**BEFORE THE INDEPENDENT COMMISSIONER
AT WAIRARAPA**

IN THE MATTER of an application by Woolworths New Zealand Ltd ("**Woolworths**") for resource consent in relation to site at 134 Main Street, Greytown known as FreshChoice Greytown

**STATEMENT OF REBUTTAL EVIDENCE OF LEO HILLS ON BEHALF OF
WOOLWORTHS NEW ZEALAND LIMITED**

TRAFFIC

Figure 3: Google street view of access (No 124 Main Street)

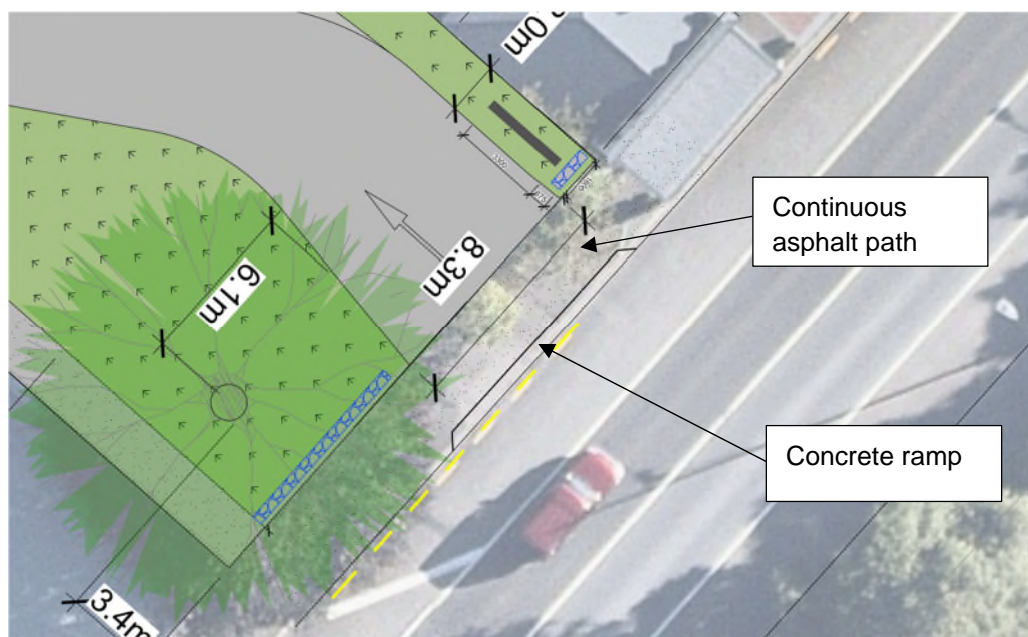
2.20 Mr Church (paragraph 9.51) questions the ability to provide a driveway that is continuous in grade / colour for pedestrian priority. The applicant's intention is

to provide a driveway similar to the existing one, with a continuous asphalt surface with a concrete ramp at the kerb. This is similar to a number of driveways in Greytown.

- 2.21 Mr Church is also concerned about the driveway strength². This will be a matter for detailed design by a Civil engineer, however I do note that while South Wairarapa District Council does not appear to have detailed design drawings for vehicle crossings, there is a Wellington City Council driveway standard (R-24-722) which includes an option for concrete ramp and asphalt footpath (at same level and grade). I am also aware of examples where the base under the asphalt has been strengthened (using concrete) rather than basecourse to improve structural integrity.

- 2.22 This treatment appears to have been used in a number of locations in Greytown already. The Google images below show two examples and I have updated the proposed driveway design as per Figure 5 below for further clarity.
